## **BLACKWOOD COMMERCIAL PARK SUBDIVISION, UNIT ONE, RESUBDIVISION OF PART OF LOTS 1 & 2**

APPLICATION NUMBER 6 DATE August 21, 2003

REQUEST Subdivision

# BLACKWOOD COMMERCIAL PARK SUBDIVISION, UNIT ONE, RESUBDIVISION OF PART OF LOTS 1 & 2

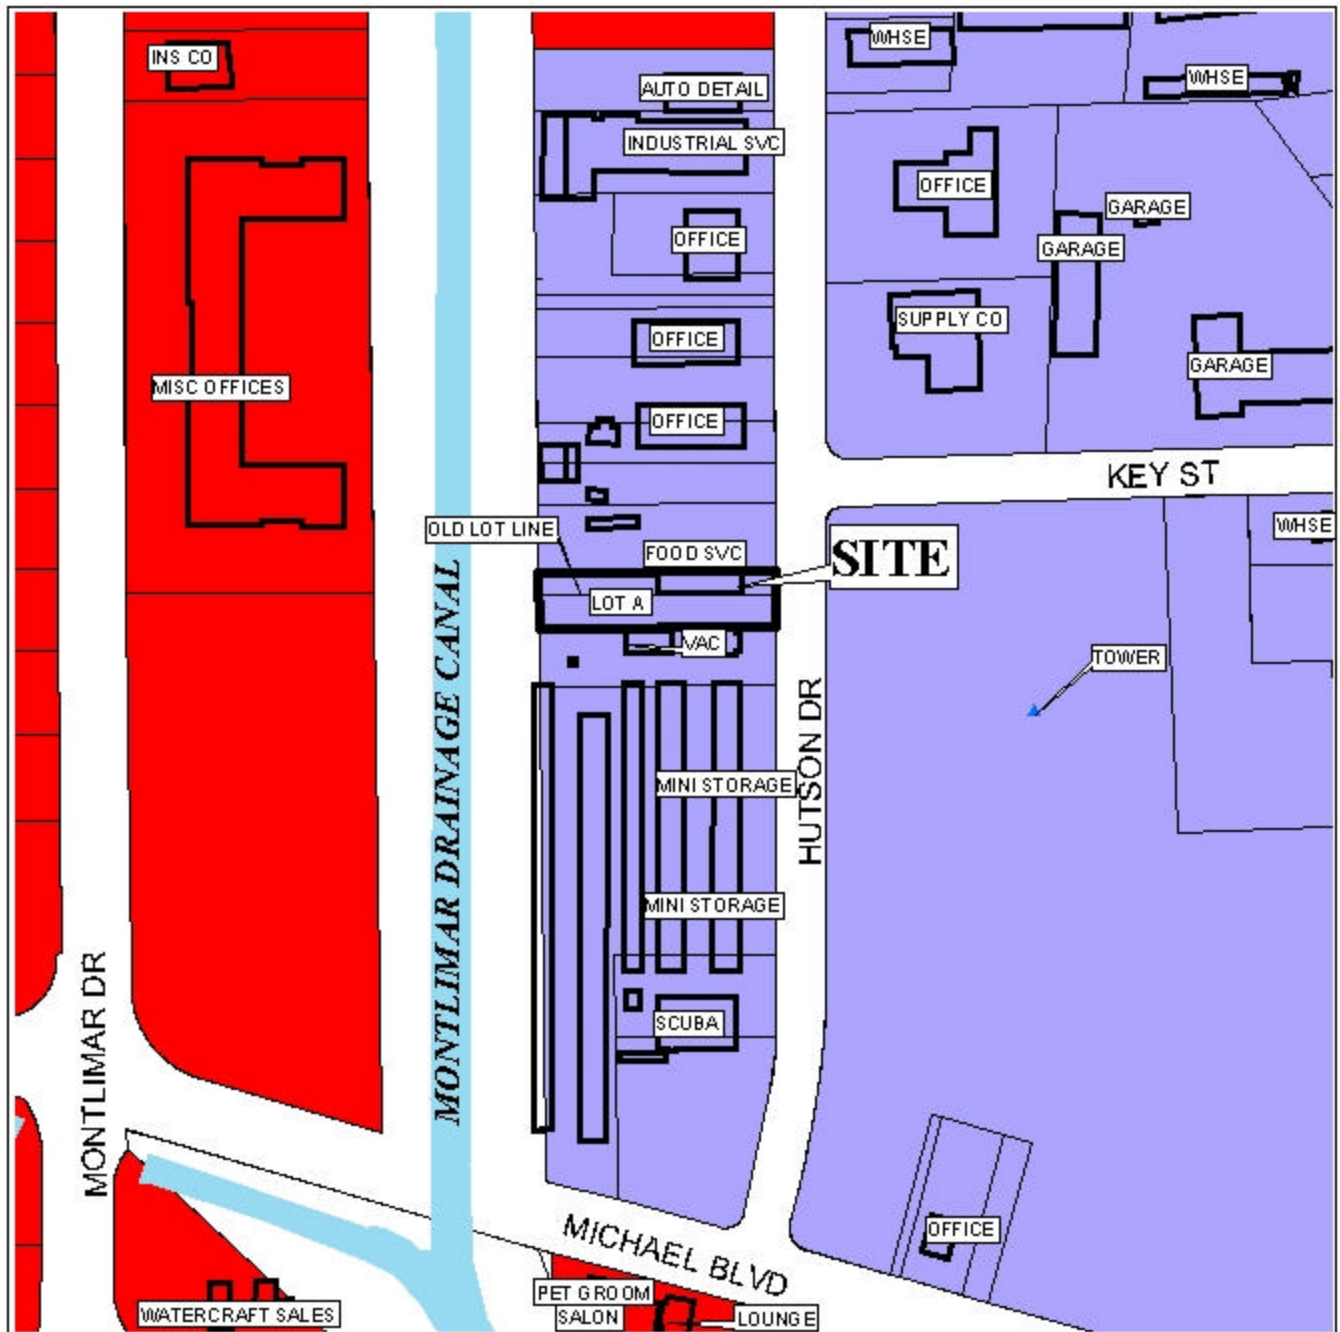
As a means of access management a note should be placed on the final plat stating that the development is limited to the existing curb cut.

The 25-foot minimum building setback line is not shown but would be required on the final plat.

With modifications, the plat will meet the minimum requirements of the Subdivision Regulations and is recommended for Tentative Approval subject to the following conditions: 1) the placement of a note on the final stating that the development is limited to the existing curb cut to Hutson Drive; and 2) placement of the required 25-foot minimum building setback line on the final plat.
